Modification Recommended Service Note

P5002B Keysight Streamline Vector Network Analyzer

Serial Numbers: From MY61100009 to MY61100135

Potential lifted front panel overlay

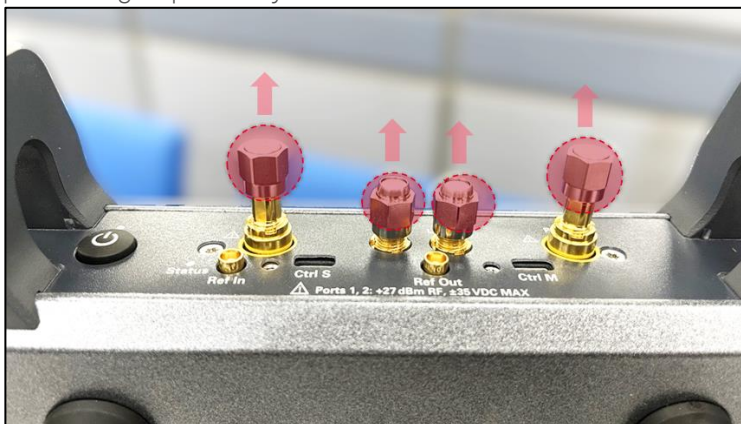
Keysight streamline series vector network analyzer (VNA) of serial number range identified in service note cover page might potentially exhibit the following lifted front panel overlay symptom.

Apart from cosmetic imperfections, the lifted front overlay could have led to non-fully attached *Ctrl S* micro-HDMI cable connector in multi-VNAs setup configuration.

-> Apply this service note only if end users' VNA is exhibiting the following symptom.

Procedure to replace the front panel overlay.

1. Remove the front handles. Detach the 50-ohm termination (LO-In, LO-Out, Port 1 & Port 2) or protecting caps if they are attached to the VNA.

2. Pry open the existing front panel overlay and remove it from front panel.
3. Clean the metal surface thoroughly and ensure it is free of adhesive residue.
4. Affix the new self-adhesive front panel overlay onto the metal surface.
5. Reinstall (reuse) the 50-ohm terminations and port protecting caps accordingly.

6. Reinstall (reuse) the front handles.
